ALBERTA TRANSPORTATION SPRINGBANK OFF-STREAM RESERVOIR PROJECT
RESPONSE TO NRCB AND AEP SUPPLEMENTAL INFORMATION REQUEST 1, JULY 28, 2018

Dam Safety
May 2019

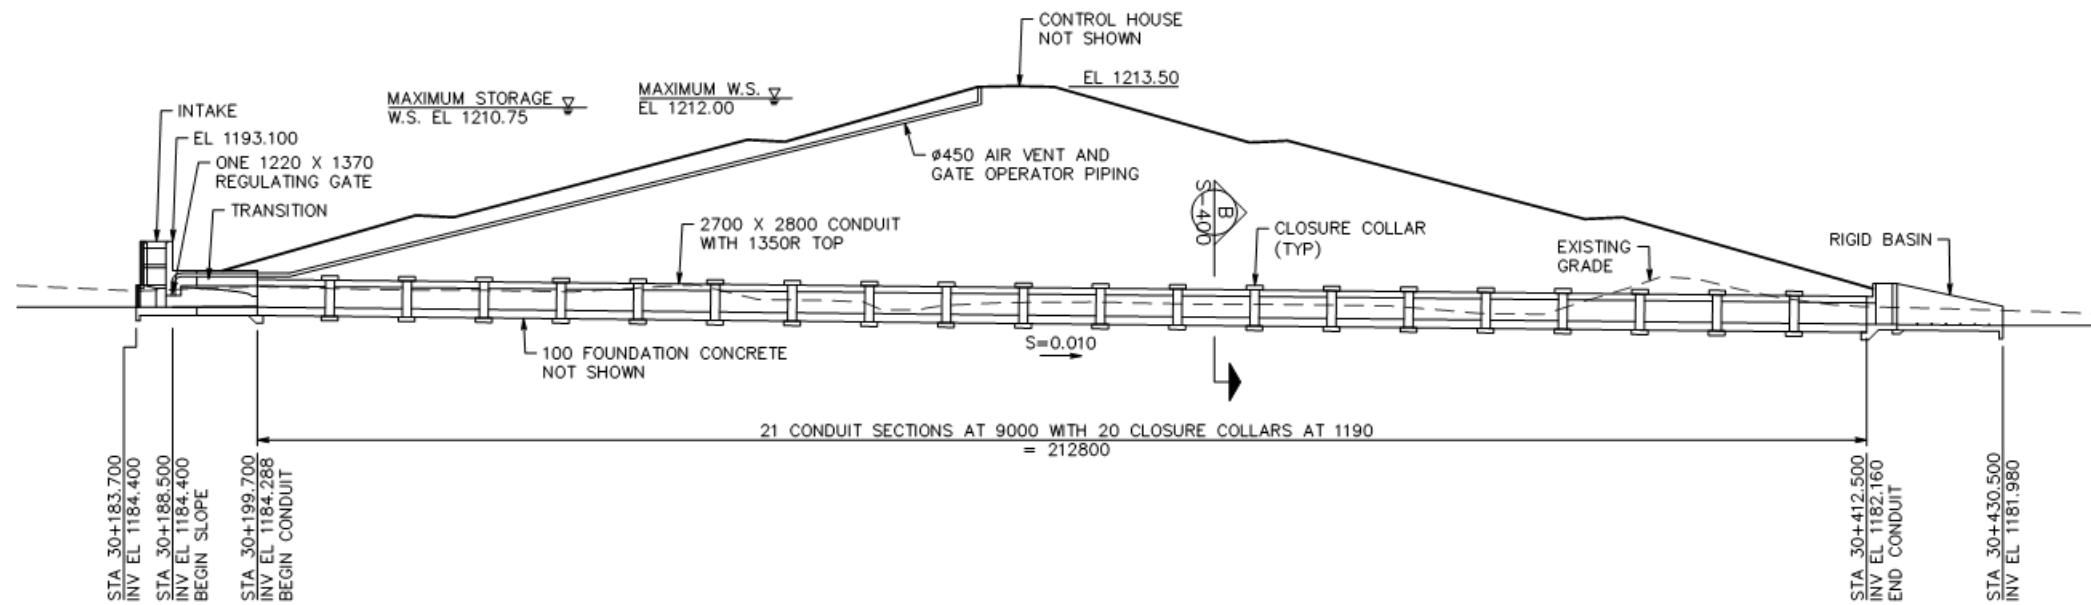
Alberta Transportation states that *The low-level outlet structure (Figure 3-10) consists of an approach channel, discharge gate, gatehouse, discharge conduit and outlet channel. The gate is operated locally by the gatehouse. Figure 3-10 is labeled Low Level Outlet but only shows the basin at the downstream toe. The photo in this figure is a picture of another project with a similar basin but with twin conduits that are round instead of the actual conduit shape for this project.*

- A designed channel will be excavated from the stilling basin to the unnamed creek.
- c. A section through the LLOW is provided in Figure IR475-2.

Backfill and seepage control measures will be developed and refined as design progresses.

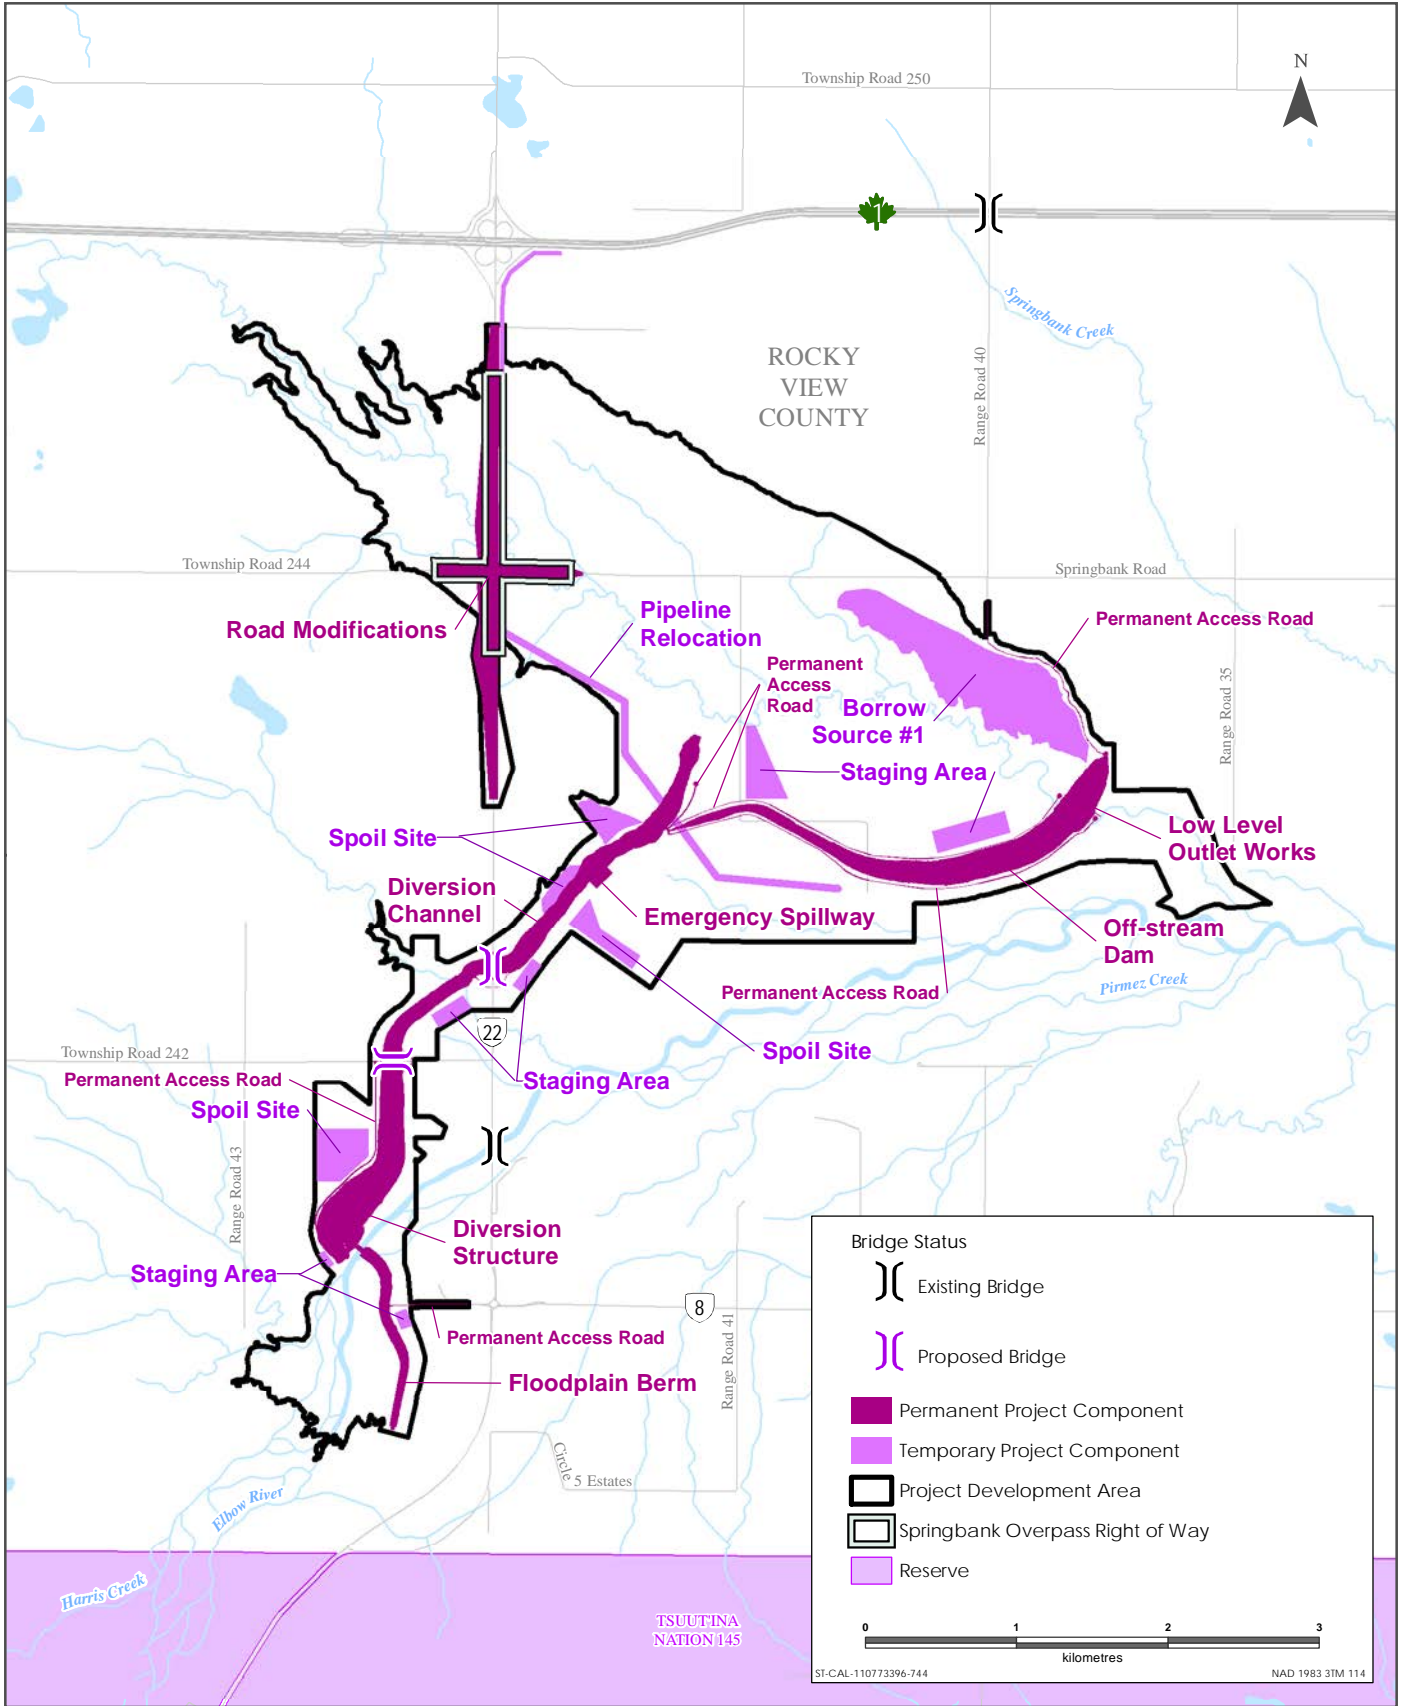
Alberta Transportation states *See Figure 3-1 for the locations of temporary construction laydown areas, which typically include a site trailer, toilet facilities, and areas for parking, fueling, waste and recycling bins, and storage of equipment and materials.* Temporary construction laydown areas are not shown on Figure 3-1.

- a. Provide details for locations of the temporary construction laydown areas. Update the EIA to reflect the proper locations.

- a. The reference to Figure 3-1 is incorrect. The reference should have stated Volume 4, Appendix D, Figure 2-2. Figure IR482-1 (a duplicate of Figure 2-2) illustrates the temporary construction laydown areas (staging areas).

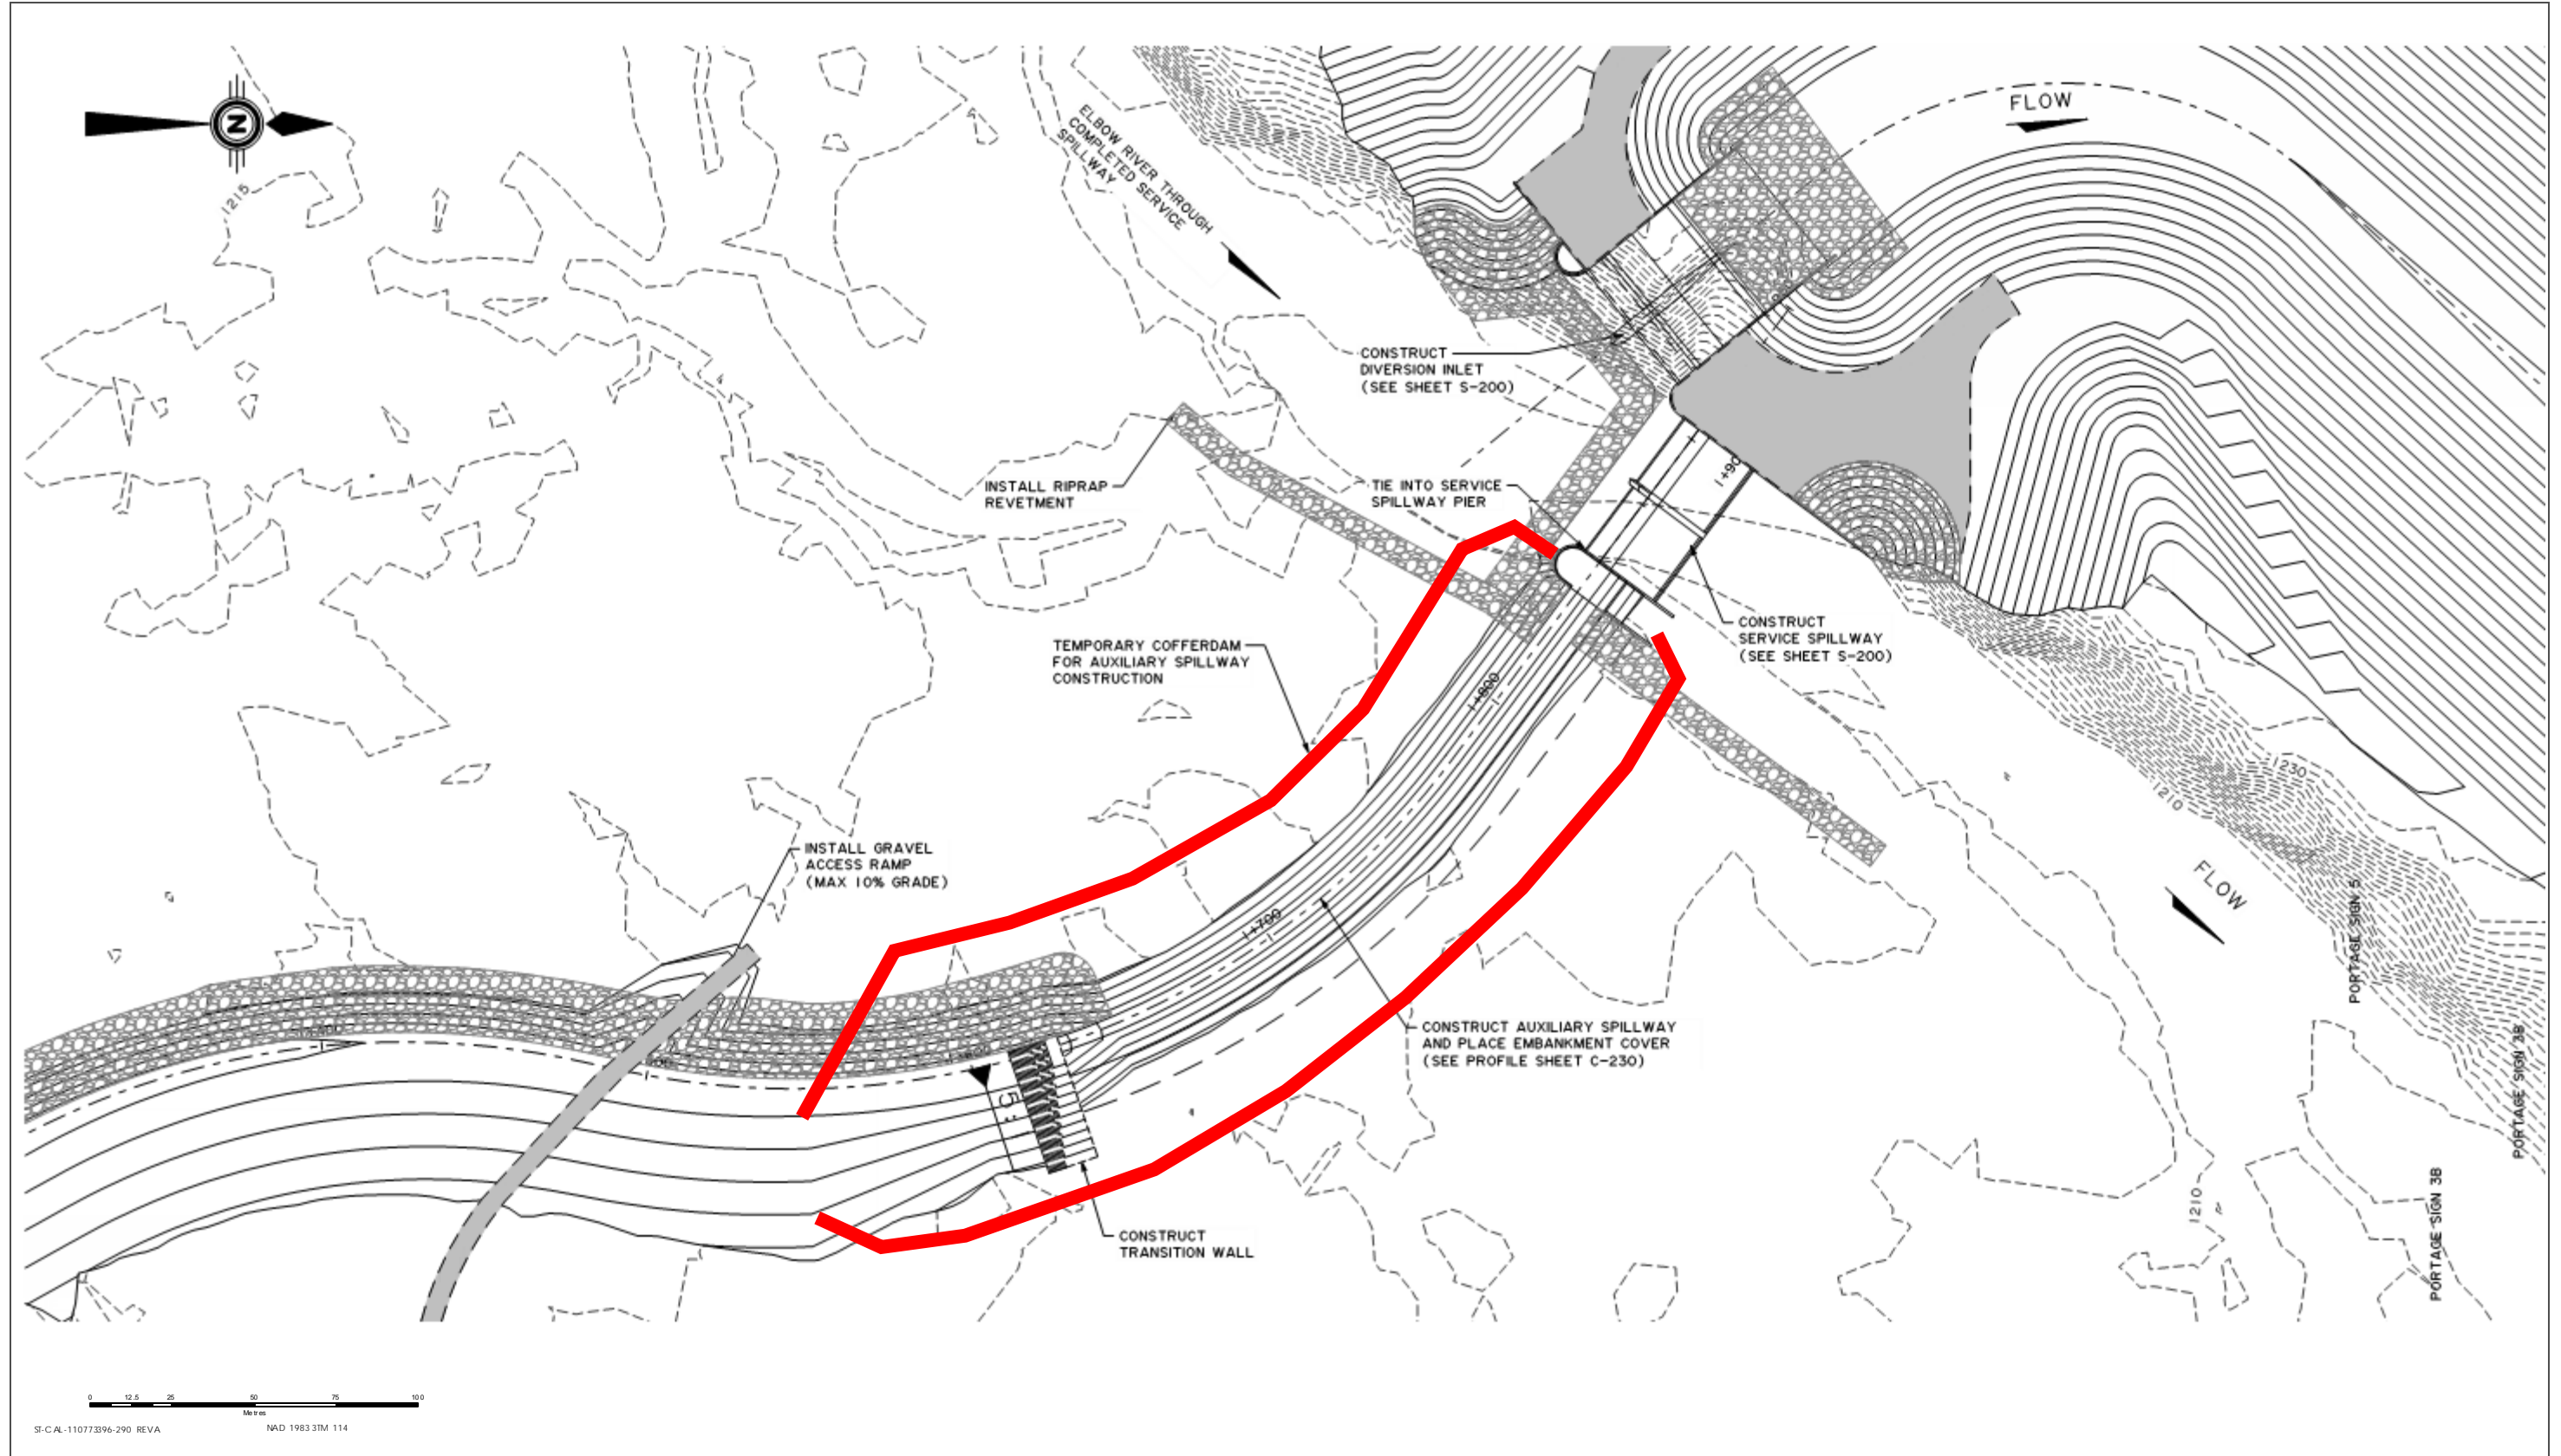
- a. Explain the basis for selection of the 1:10 year flood event for the cofferdam.
- b. Given that the auxiliary spillway abuts with the service spillway, clarify the water management requirements and construction staging for the auxiliary spillway considering instream construction windows.

- a. A 1:10 year flood was selected based on the relative low consequence of failure and short exposure duration. Damages associated with failure of the cofferdam are limited to the in-progress construction works, which are primarily cast-in-place concrete structures. The cofferdam will be in place for one flood season of Elbow River.

- b. Construction of the service spillway will include the right abutment pier. Following construction of the service spillway, the river channel will be re-diverted through the service spillway and the isolation works for the auxiliary spillway will tie-in with the right abutment pier, which is constructed to an elevation higher than the 1:10 year flood water surface elevation. Work within the water course is anticipated to occur within the approved instream construction windows. Figure IR487-1 provides the proposed location of cofferdams for the auxiliary spillway.

Figure IR495-1 The Diversion System, North End of Floodplain Berm

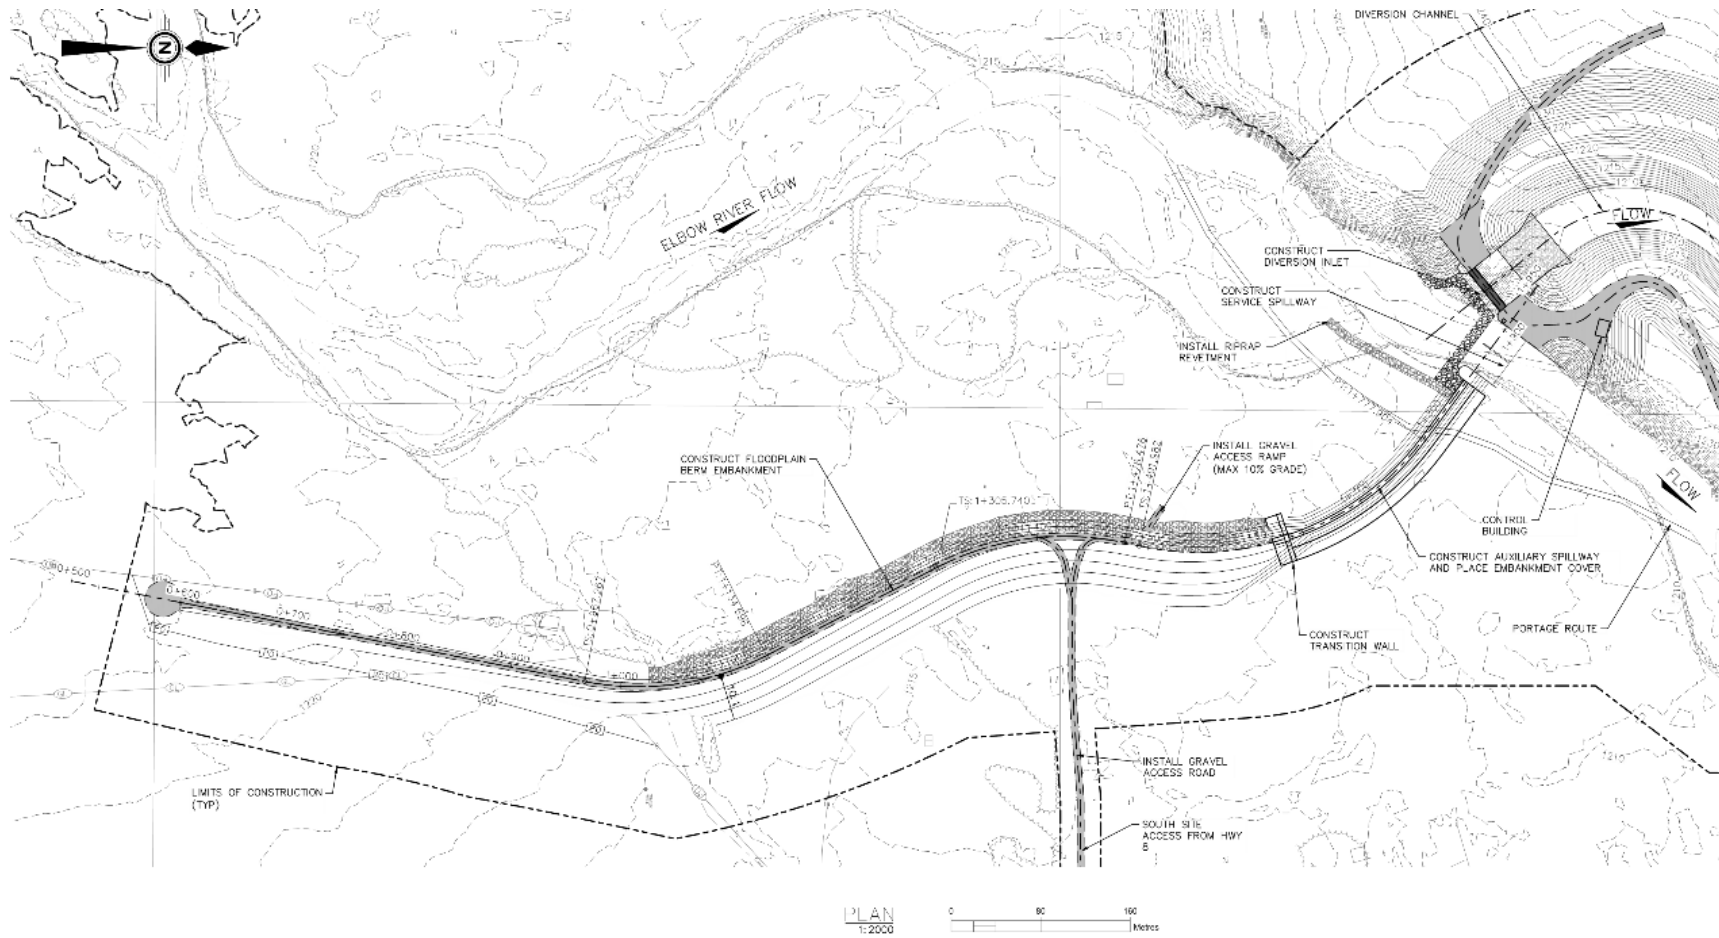
Figure 3-2 shows a floating boom upstream of the diversion structure.

- a. The floating boom has been removed from the design due to safety concerns. No floating booms are currently proposed upstream of the diversion structure. Figure IR495-1 is an update to Volume 1, Figure 3-2, which has the floating boom removed.

Figure IR528-1 Calculated Diversion Structure Hydrographs

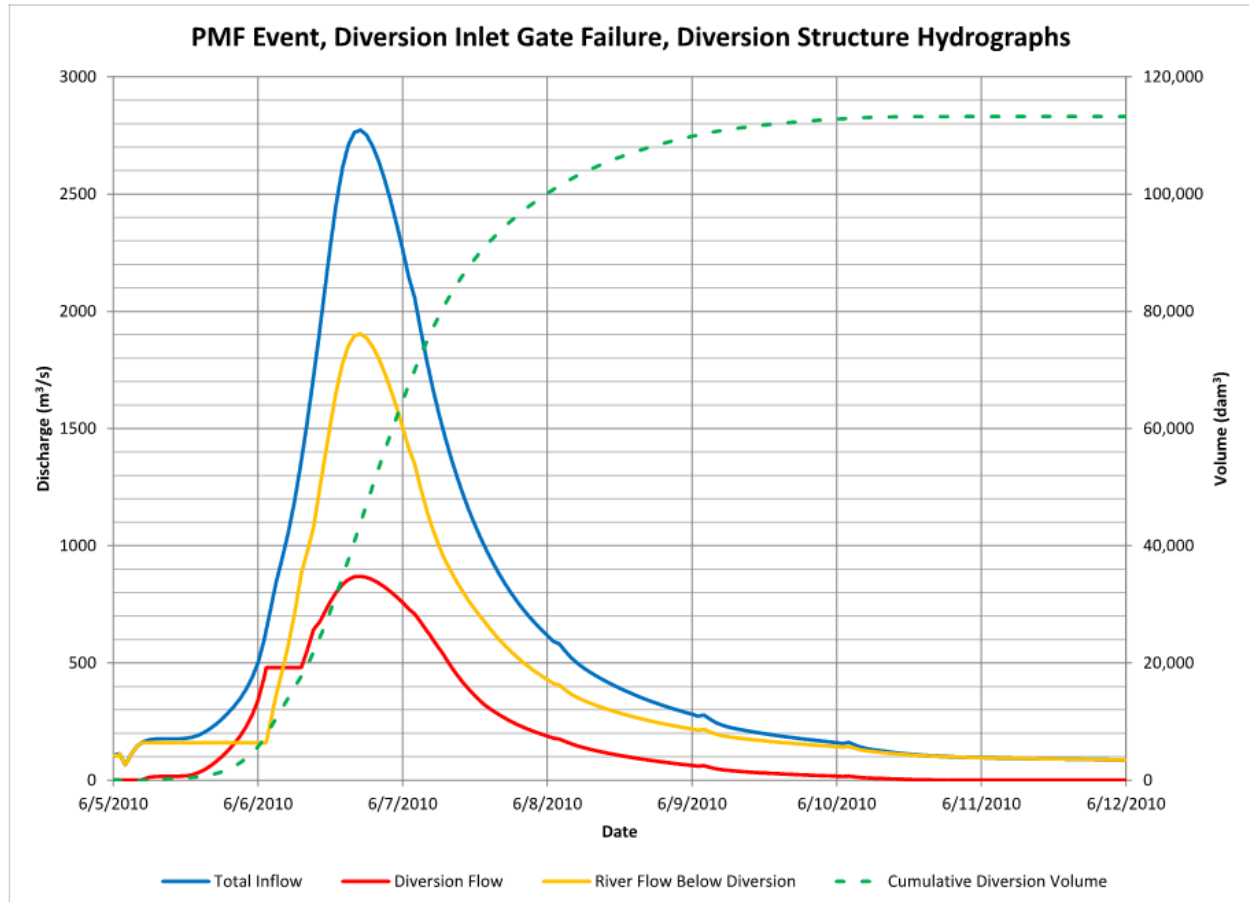
- a. Provide details of the freeboard calculation including routing and wind-wave analysis.
- b. The starting reservoir elevation (on Figure 39) is said to account for sedimentation and local runoff. Does it also account for stored water remaining after passage of the antecedent rainfall event? Explain why or why not. Provide a complete figure showing inflow and outflow hydrographs and reservoir levels throughout the antecedent event and the PMF.

Figure IR528-1 presents the calculated inflow hydrograph.
